TOWN OF LAKEVILLE MEETING POSTING & AGENDA

Name of Board or Committee:	Planning Board
Date & Time of Meeting:	Thursday, June 8, 2023 at 7:00 p.m.
Location of Meeting:	Lakeville Police Station 323 Bedford Street, Lakeville, MA 02347
Clerk/Board Member posting notice:	Cathy Murray

2. **Public Hearing (7:00) Stowe Estates – 35 Myricks St, continued** upon the application for Approval of a Definitive Plan submitted by JIJ Properties, Inc., for a three (3) lot subdivision, Assessors Map 017, Block 004, Lot 003-01

- Plans entitled "Definitive Residential Subdivision, "Stowe Estate" at 35 Myrick Street, Lakeville, Massachusetts" prepared by Zenith Consulting Engineers, LLC, dated 2-13-23.
- Report entitled "Stormwater Management Report, Definitive Residential Subdivision, "Stowe Estates," 35 Myricks Street, Lakeville, MA" prepared by Zenith Consulting Engineers, LLC, dated February 13, 2023.
- Form C Application.
- Letter requesting waivers from the Town of Lakeville's Rules and Regulations of the Planning Board Governing the Subdivision of Land, prepared by Zenith Consulting Engineers LLC, dated March 3, 2023.

DEFINITIVE SUBDIVISION
LOTTLING PLAN
STOWE ESTATES
LAKEVILLE, MASSACHUSETTS
JJJ PROPERTIES, INC.
6 SAND TRAP LANE
LAKEVILLE, MASSACHUSETTS

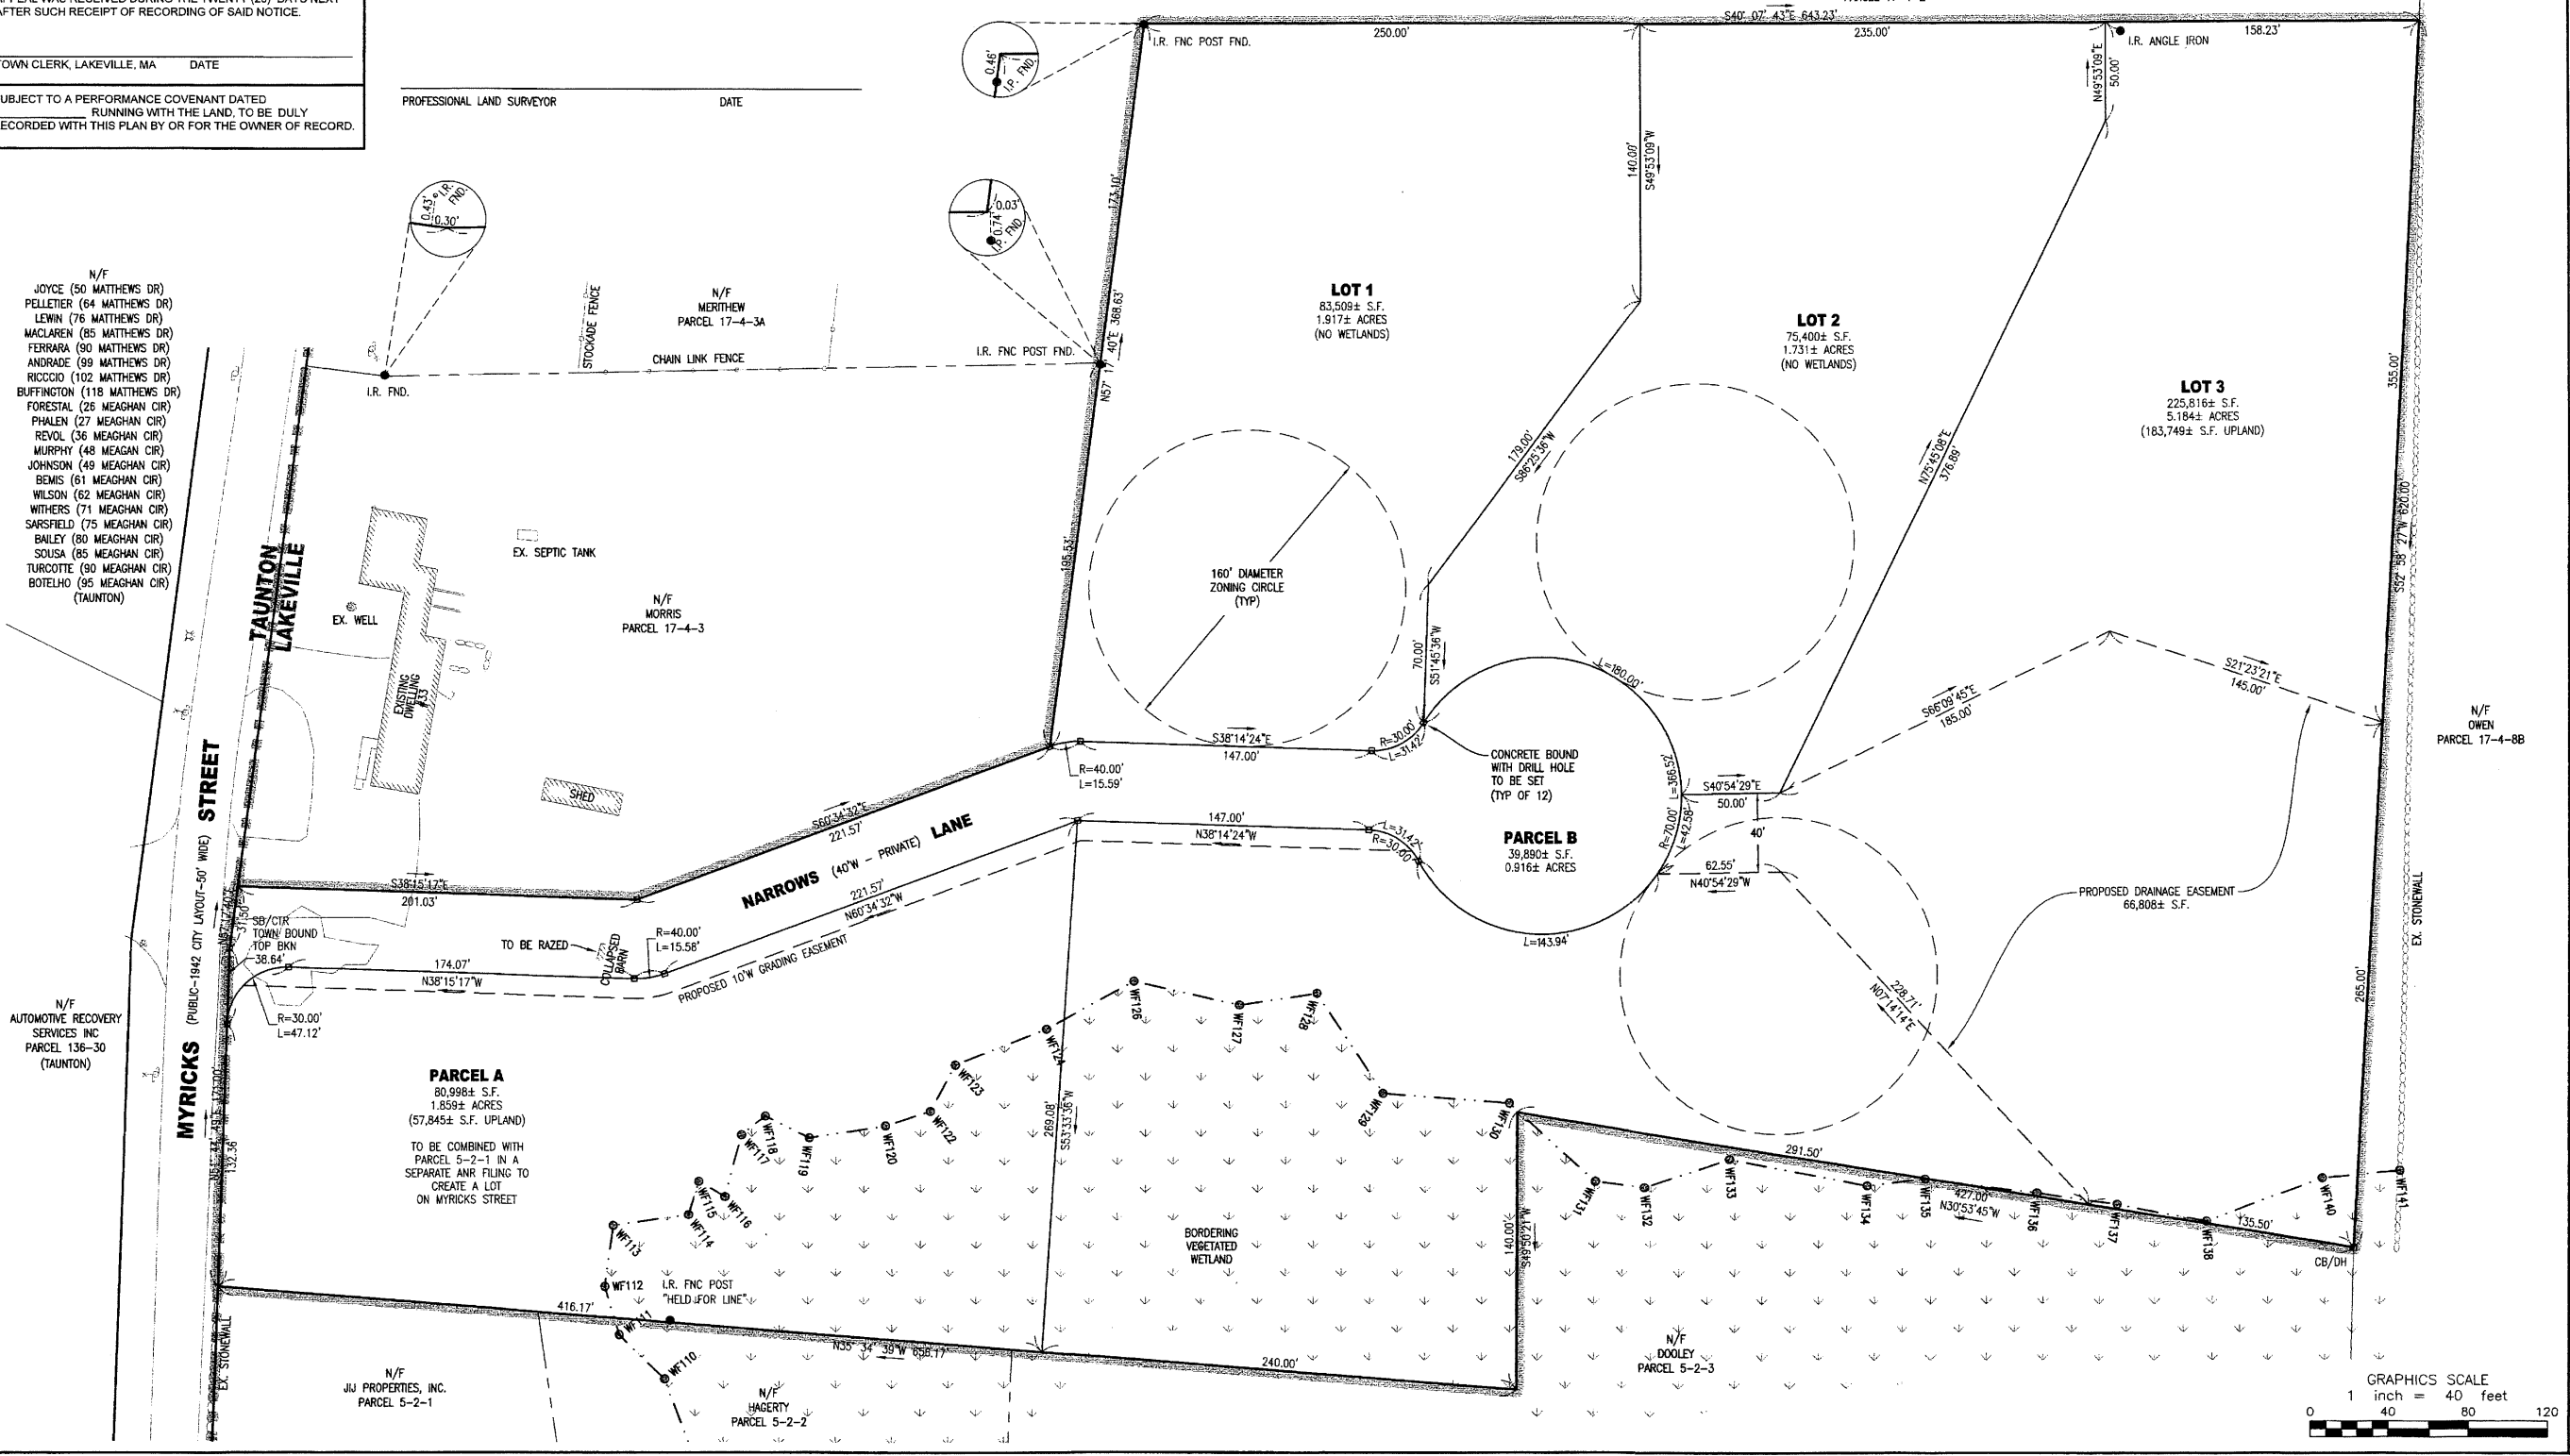
8. Section III.C.2.w requires a table showing areas of all the proposed lots, areas reserved for streets or rights-of-way, and easements.
9. Section III.C.2.x requires an upland circle shown on each of the lots consistent with the Lakeville Town Bylaws. The plans show the upland circle for lot three shown in the proposed drainage easement.

Response: An area table has been added to the Lotting Plan.

DEFINITIVE SUBDIVISION GRADING & DRAINAGE PLAN
 LAKEVILLE, MASSACHUSETTS
STOWE ESTATES
JJ PROPERTIES, INC.
 6 SAND TRAP LANE
 LAKEVILLE, MASSACHUSETTS

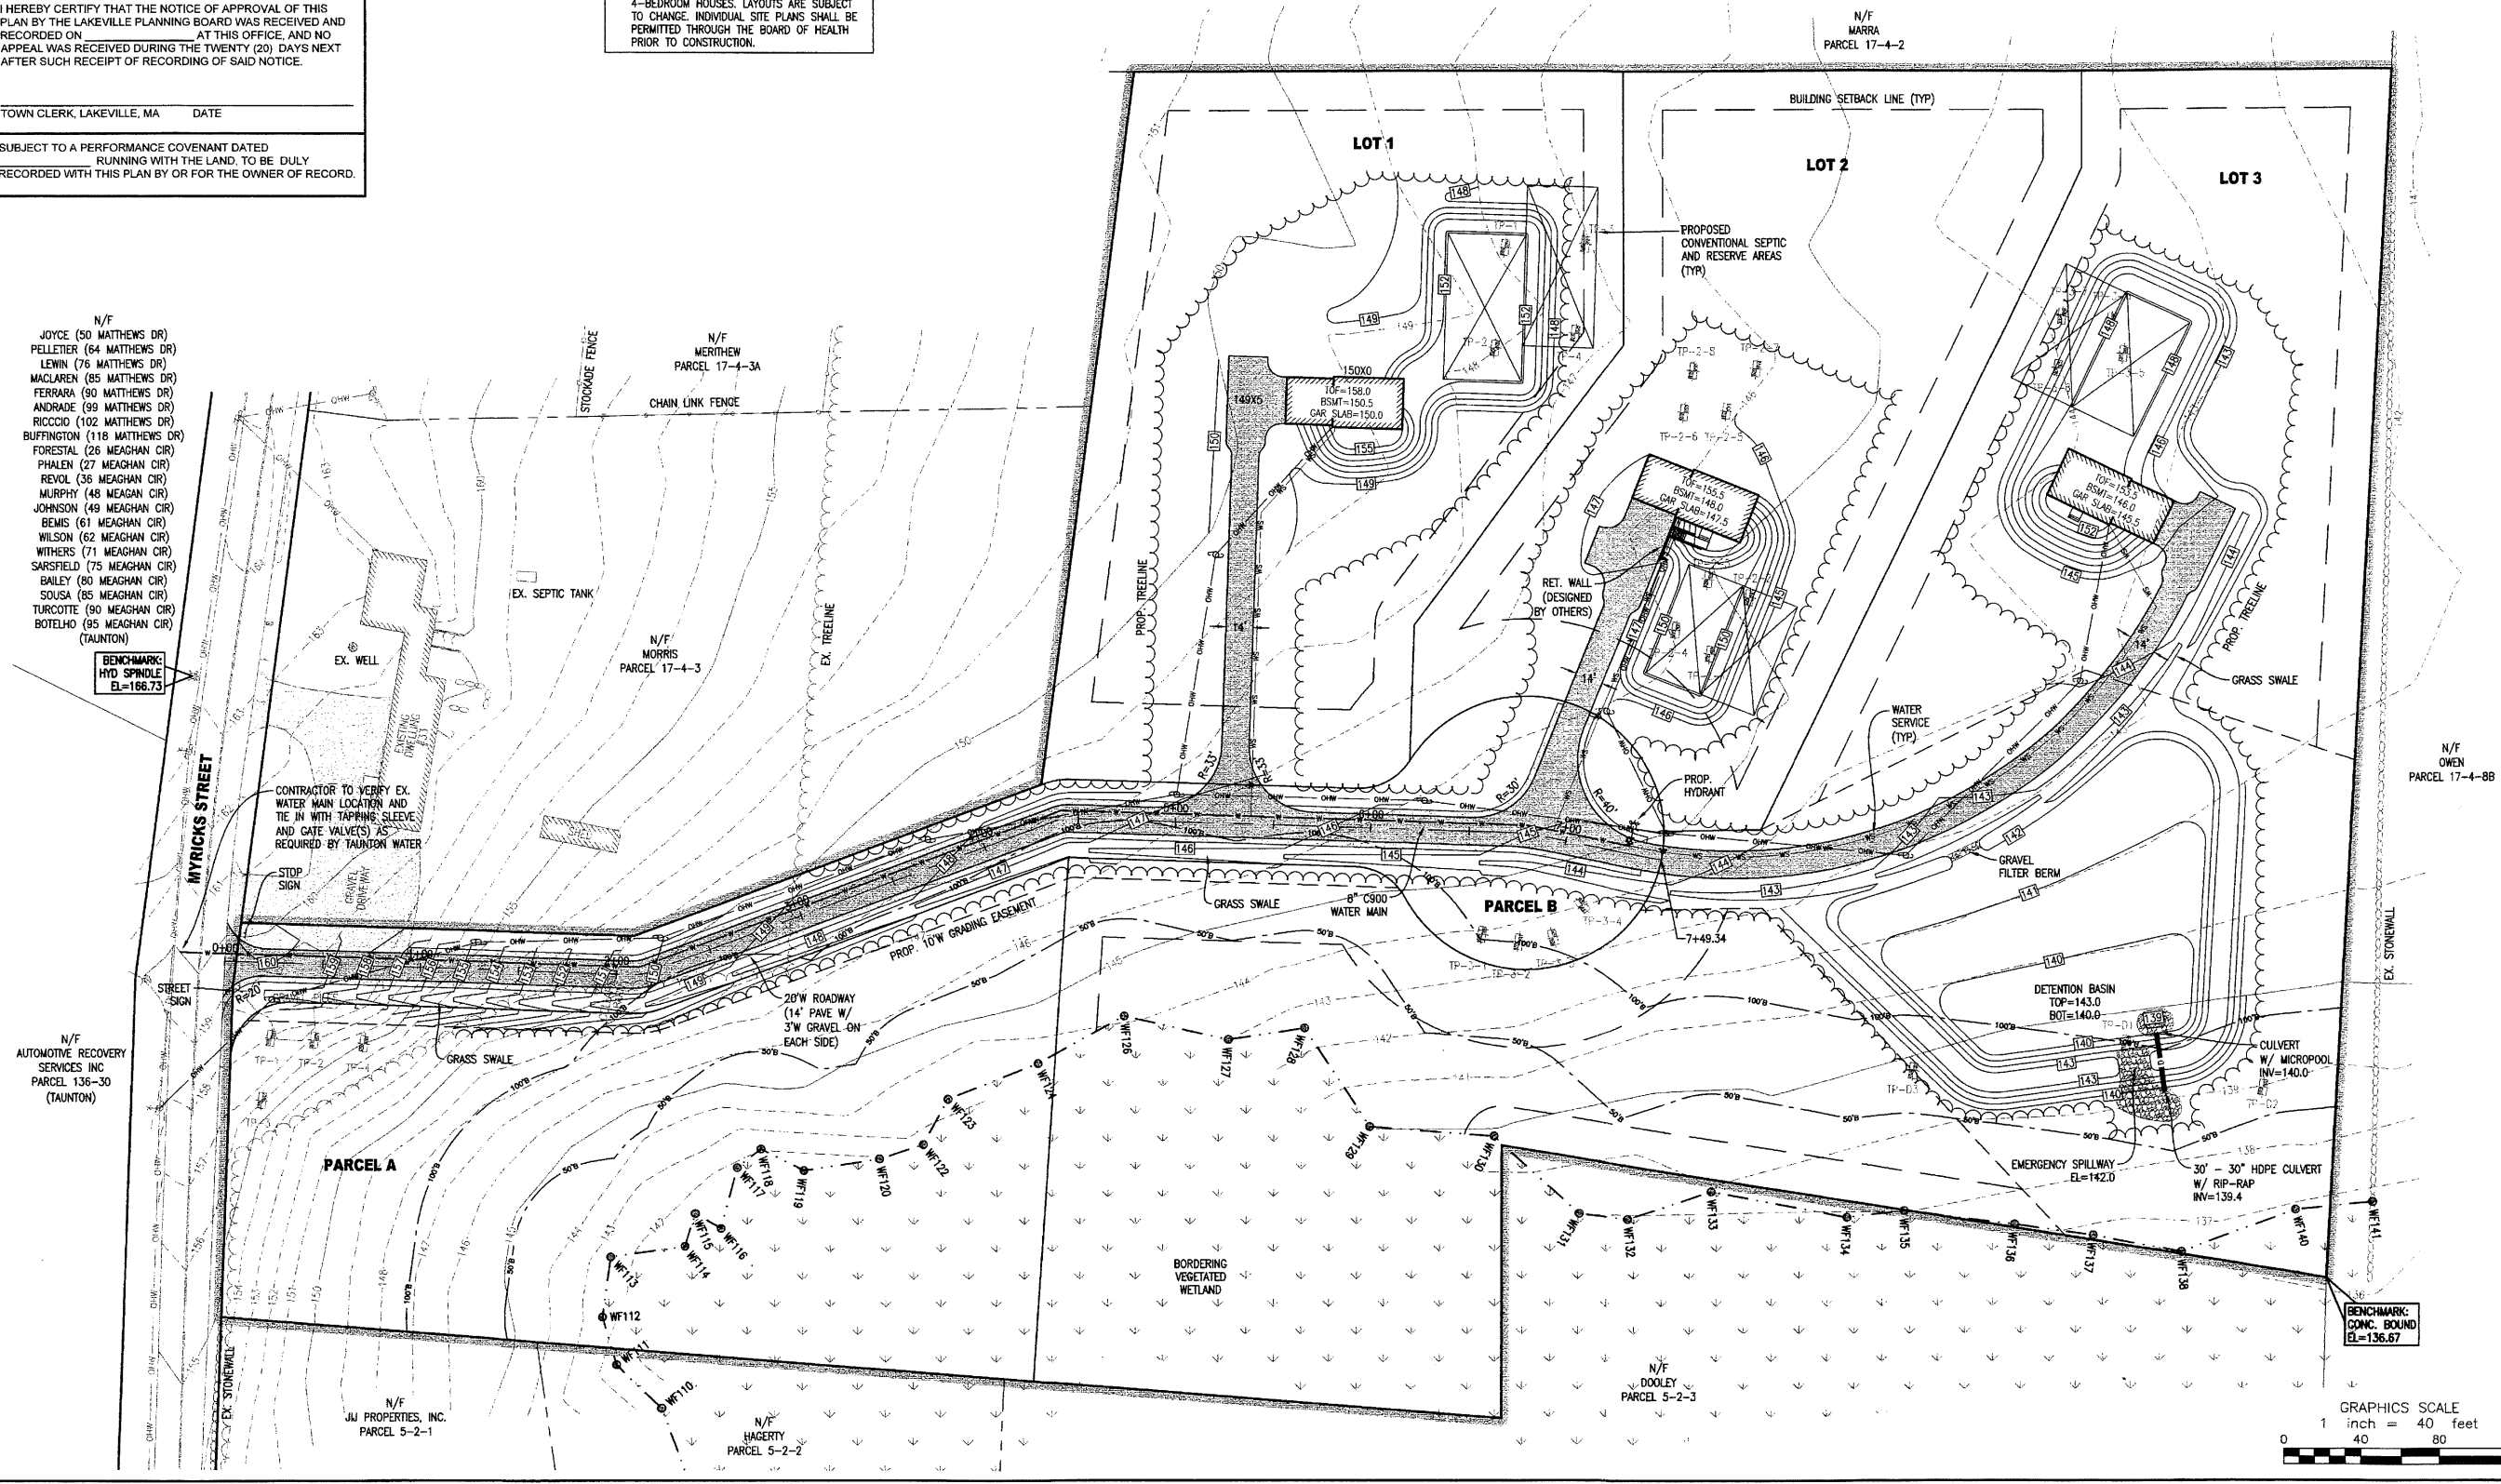
3. Section III.C.2.k requires building setback lines be included on the plans. The plans do not include any building setback lines.
4. Section III.C.2.l requires the locations of all easements on the plans. The project includes a large drainage easement on Lot 3.

5. **EP: Section III.C.2.o requires the proposed layout and utilities to be shown on plan and profile sheets. The plans show proposed water and electric service on the Grading and Drainage Plans. They are not shown on the proposed road profile.**

Response: Building setback lines have been added to the Grading and Drainage Plan.

Response: The proposed driveways are 14' wide and have greater than 3' curb return radii. Labels have been added to the Grading and Drainage Plan.

Response: A street sign is specified on the Grading and Drainage Plan on the southern side of the intersection.

ROADWAY CROSS SECTION DETAIL
NOT TO SCALE

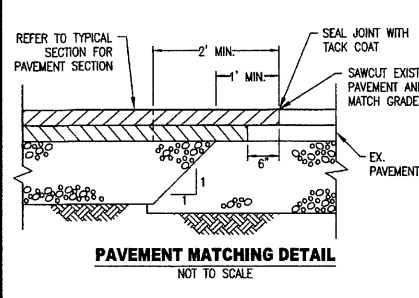
- 17. EP: Section IV.B.6.g requires the minimum roadway width for Minor Streets be twenty-four feet. The proposed cross section includes a 14 foot wide pavement width with a 3 foot wide gravel strip on either side of the pavement. The Roadway Cross Section Detail labels the road width as twenty feet. This includes the fourteen foot pavement and three foot gravel strips. The detail describes the 3-foot gravel strips as processed gravel. We recommend more detail be provided for this specification, consistent with MassDOT Standard Specifications. We assume this is proposed to be ¾-1-1/2 inch crushed stone, but the applicant should specify. The applicant has requested a waiver for reducing the width from twenty-four feet to fourteen feet with 3 foot wide gravel shoulders.**

- 18. EP: Section IV.B.6.h requires roadway pavement to be Class I Bituminous Concrete Pavement Type I-1. This type of pavement should be specified on the detail.**

10. **EP: The roadway cross section detail shows the side slopes of the drainage swale to be 2:1. We recommend this slope be flattened to a minimum of 3:1 to ensure adequate stabilization and maintenance, including mowing.**

Response: The Roadway Cross-Section Detail has been revised to specify gravel shoulder requirements.

Response: The Roadway Cross-Section Detail has been revised to specify Type I-1 pavement.

Response: Swale sideslopes have been revised to be 3:1 slopes.

DETECTION BASIN DETAIL
NOT TO SCALE

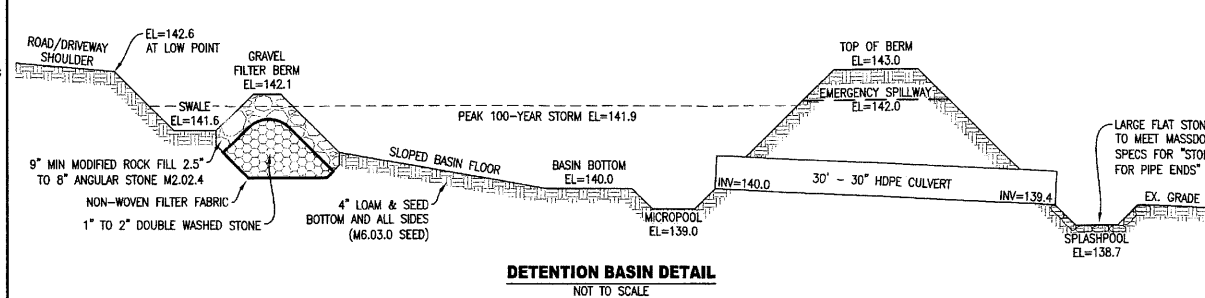
9. **EP: We recommend the applicant provide a rip-rap pad detail for the location downstream of the outlet pipe from the detention basin. We recommend Stone for Pipe Ends, consistent with MassDOT specifications, be installed at the discharge point.**

Response: A note has been added to the basin detail to specify the splashpool stones shall meet MassDOT specs for Stone for Pipe Ends.
